## TECHNICAL BULLETIN

[Issue No.] FA-A-0185

[Title] Announcement for the change of the print position on CC-Link Remote I/O Station Communication LSI MFP2N and CC-Link Remote Device Station Communication LSI MFP3N

[Date of Issue] March 2015

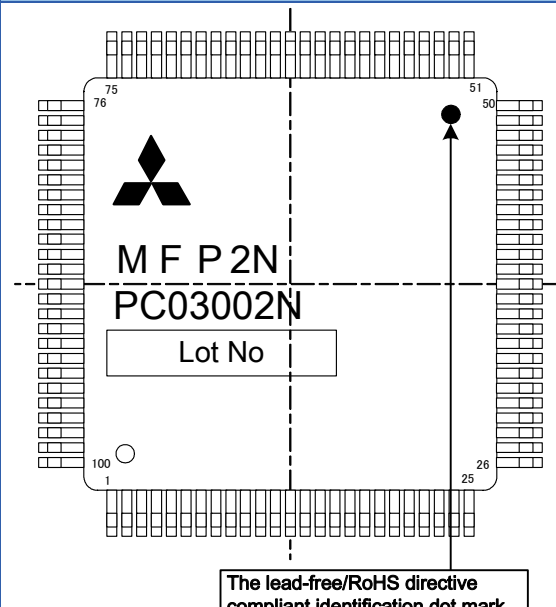
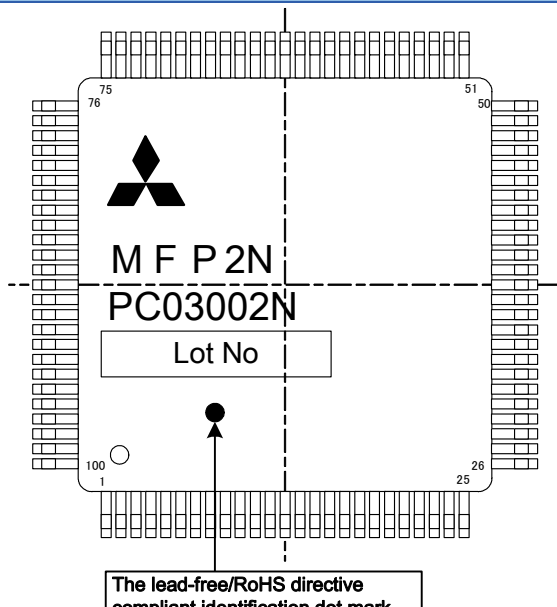
The print position of the lead-free/RoHS directive compliant identification dot mark has been changed.

| Product | Before                                                                                                                                                    | After                                                                                                                                                      |
|---------|-----------------------------------------------------------------------------------------------------------------------------------------------------------|------------------------------------------------------------------------------------------------------------------------------------------------------------|
| MFP2N   |  <p>The lead-free/RoHS directive compliant identification dot mark</p> |  <p>The lead-free/RoHS directive compliant identification dot mark</p> |

| Product | Before | After |
|---------|--------|-------|
| MFP3N   |        |       |

**(1) Only the print position on the communication LSI has been changed. The specifications and functions are not changed.**

**(2) Since the pin assignment and appearance are not changed, there is no need for any design modifications on the print board.**
